ANN ARBOR HISTORIC DISTRICT COMMISSION

Staff Report

ADDRESS: 312 S Ashley Street, Application Number HDC20-014

REPORT DATE: February 13, 2020

HDC-2

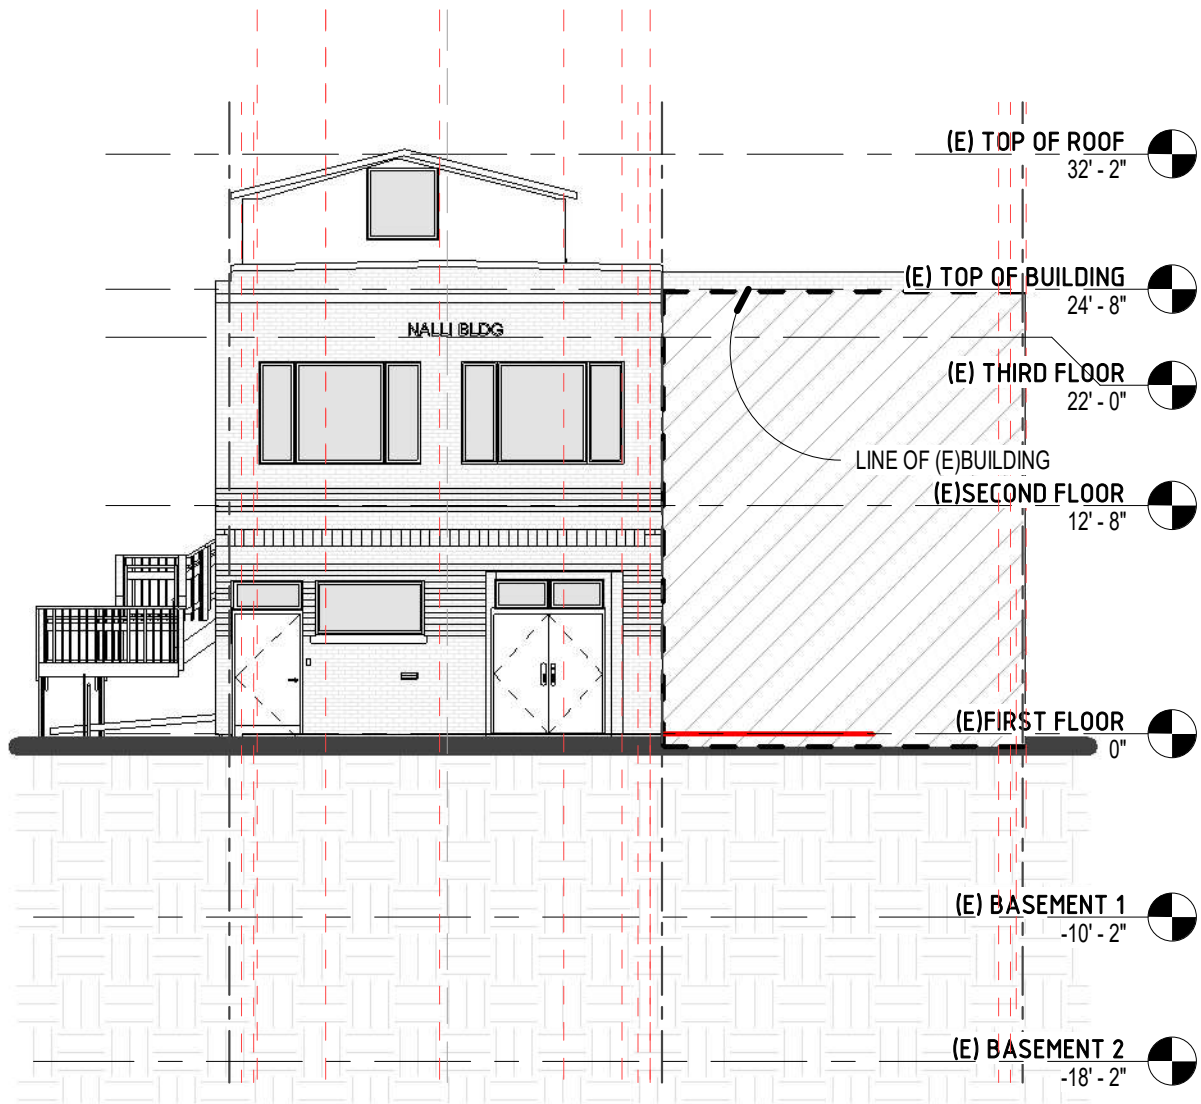
The existing structure is about 20' wide x 40' long. The addition is 7.5' taller than the top of the building (per drawing HDC-4), though the photo "East View of Roof" on HDC-2 makes it look lower on the east (front) end. Per the application, it is structurally unsafe and does not comply with current building codes/

HDC-16

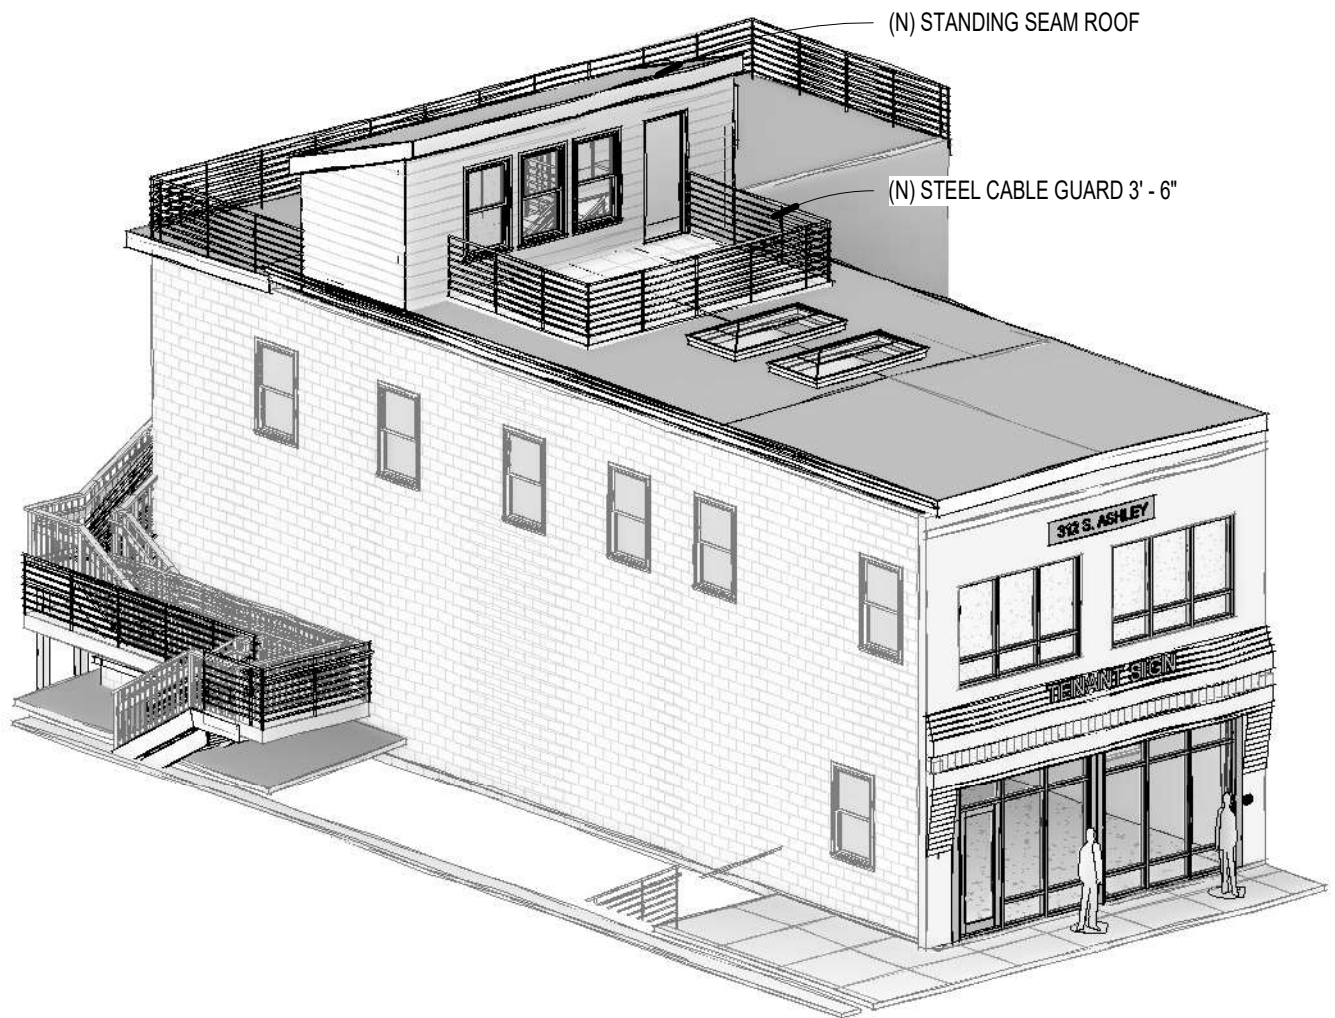
4. Roof. A new roof over most of the east/west portion of the L-shaped building is proposed. It is 1'8" taller than the existing roof. The reason for the new roof is not explained in the application. The perspective drawing HDC-16 shows the east edge of the new roof flush with the front wall of the building (there are no parapets to speak of), and slightly inset on the south side. Painted wood board trim faces the street.
